Subject: M. Randall VA – Mechanical Improvements Ph. 3
VA-573-10-600 MES# 2012 578
Addendum #1

This Addendum No. 1 issued to clarify, add to, revise, and/or delete certain items of the contract documents for this work, constitutes a part of the contract documents.

Changes to the drawings are clouded with delta 1, and dated 03-11-2015.

NEW WORK PLAN - FIRST FLOOR
Scale: 1/8" = 1'-0"

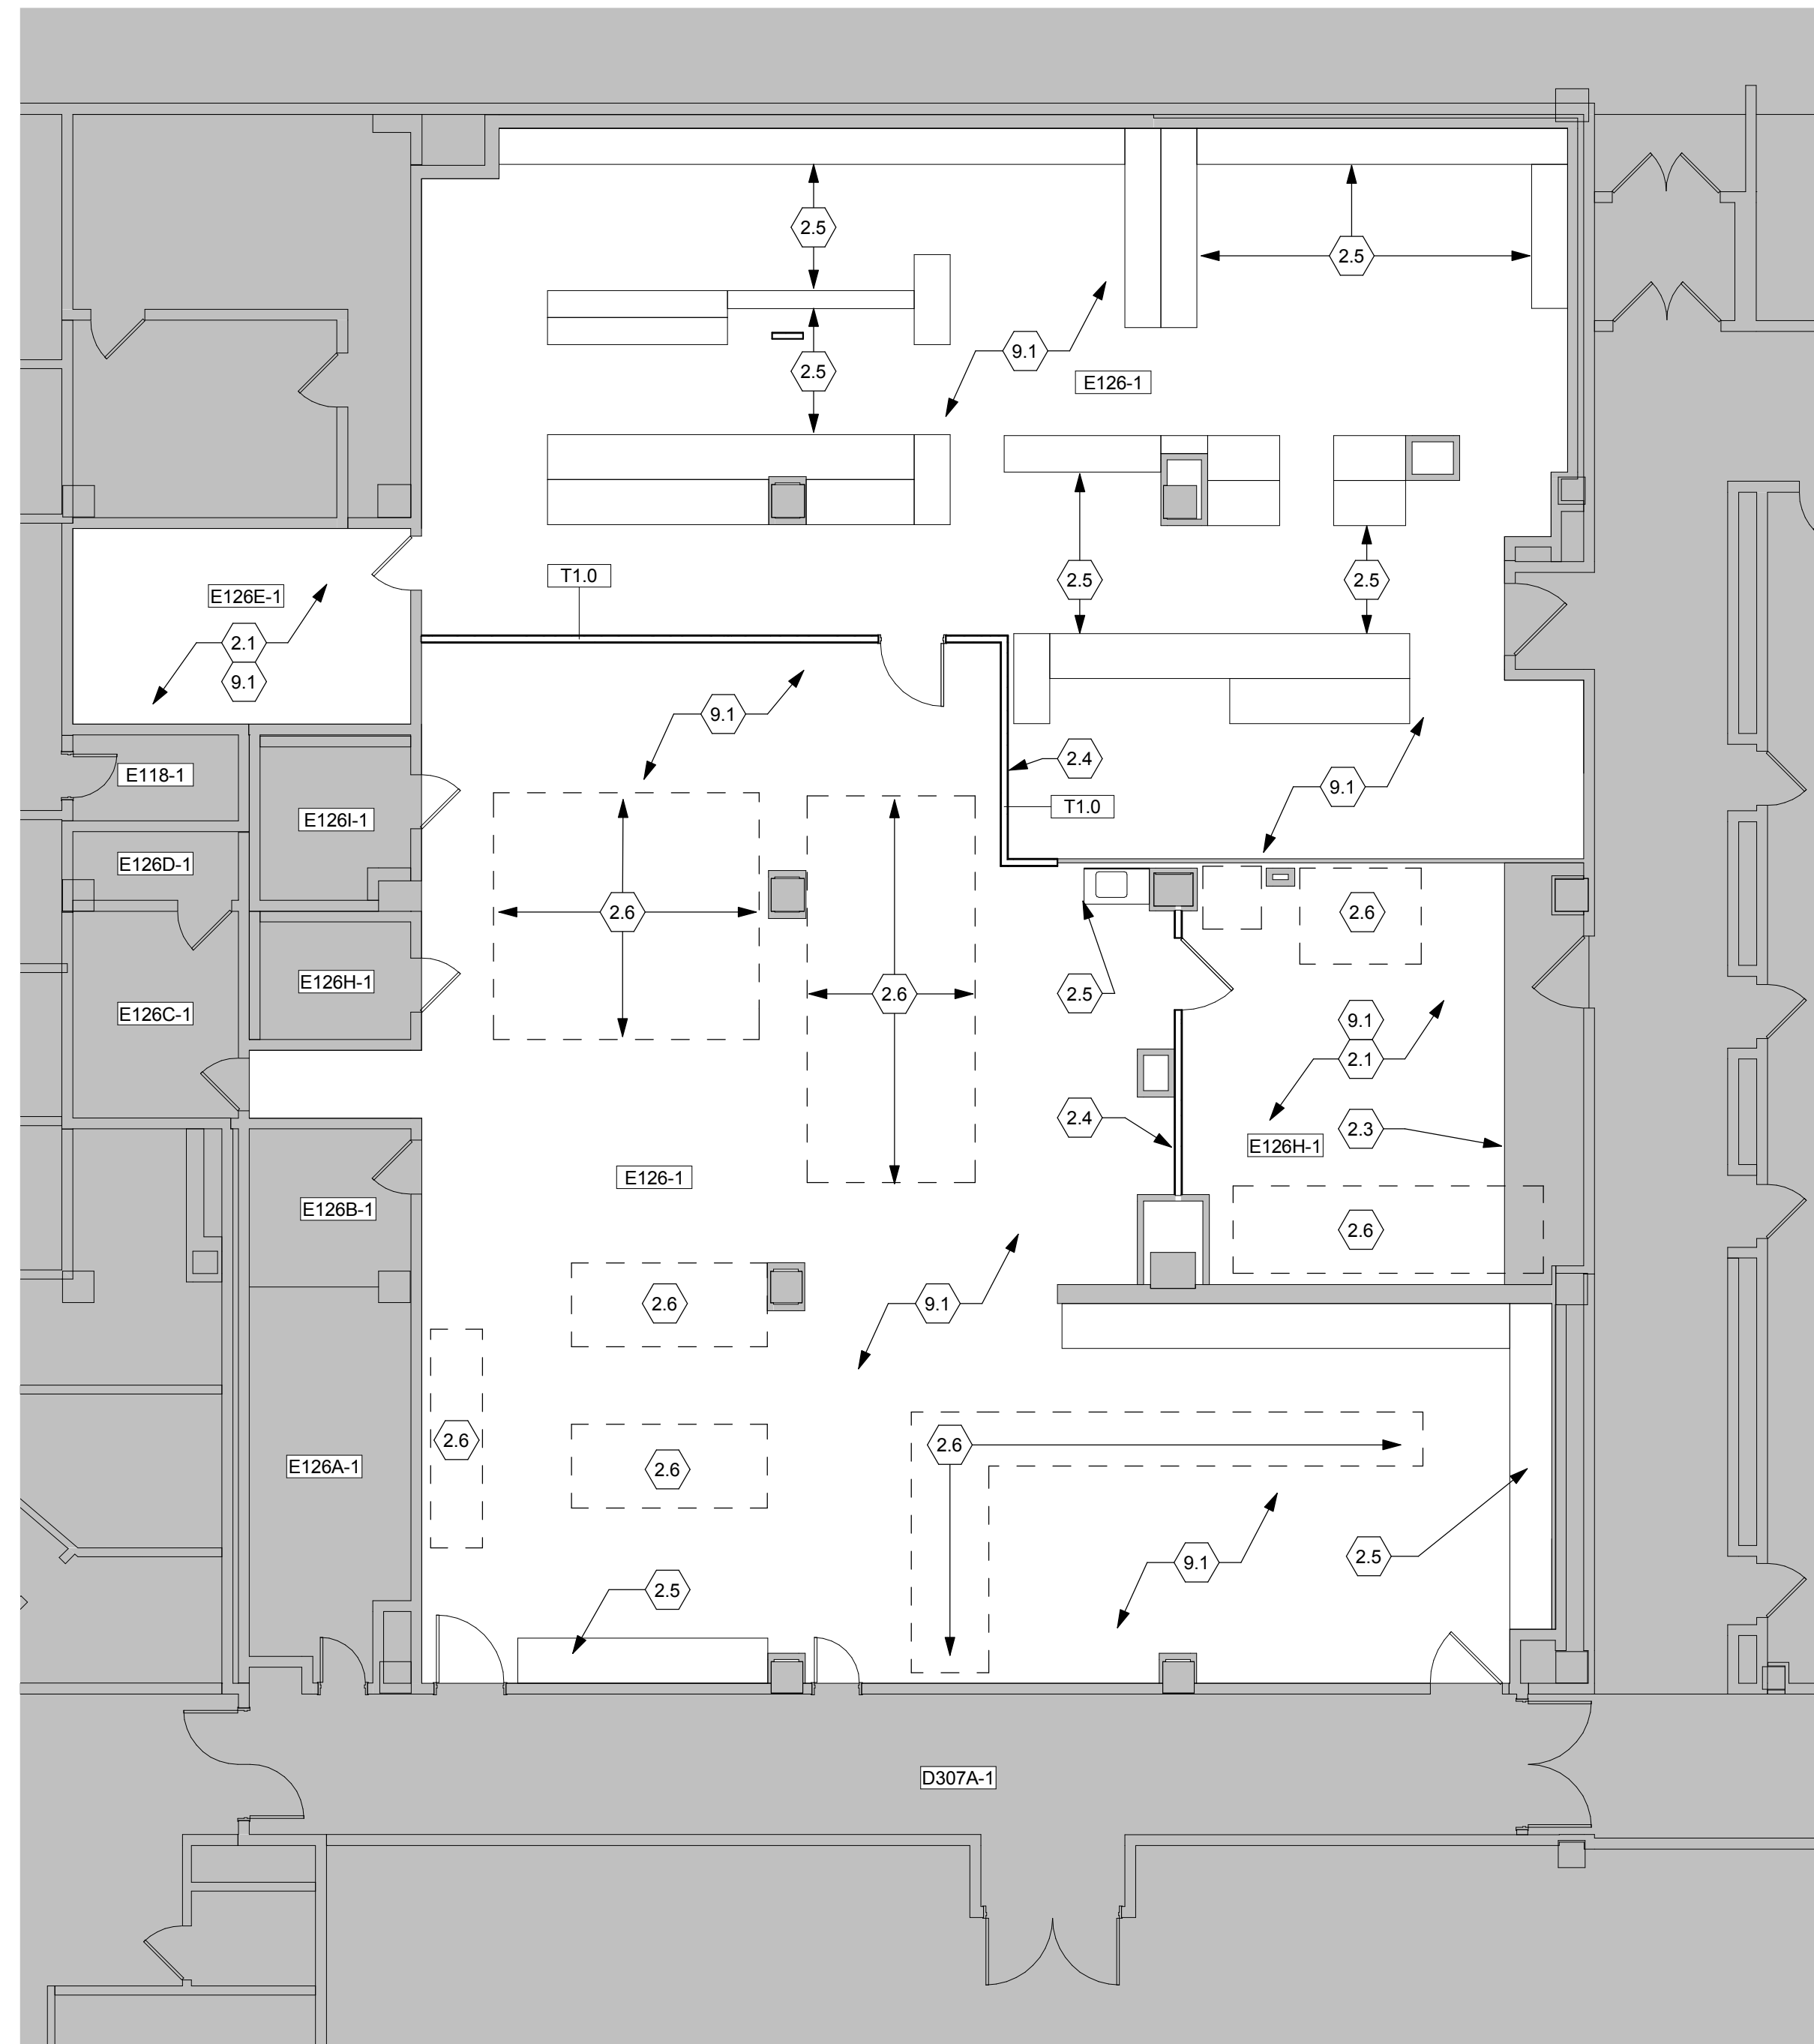
1. Drawing A-102: Added note clarifying Lab construction and demolition Base Bid unless Deduct Alternate #3 is accepted.
2. Drawing A-122: Added note clarifying Lab construction and demolition Base Bid unless Deduct Alternate #3 is accepted.
3. Drawing AD-102: Added note clarifying Lab construction and demolition Base Bid unless Deduct Alternate #3 is accepted.
4. Drawing G-202: Added note clarifying Lab construction and demolition Base Bid unless Deduct Alternate #3 is accepted.
5. Drawing MH-123: Revised ductwork at the Heat Recovery Heat Pipes from parallel flow to counter flow.
6. Drawing MH-506: Revised Plan #7 Existing AC-3E – Refurbished.
Revised notes to read as follow:

Work on this drawing is deduct if Deduct Alternate #3 is accepted.
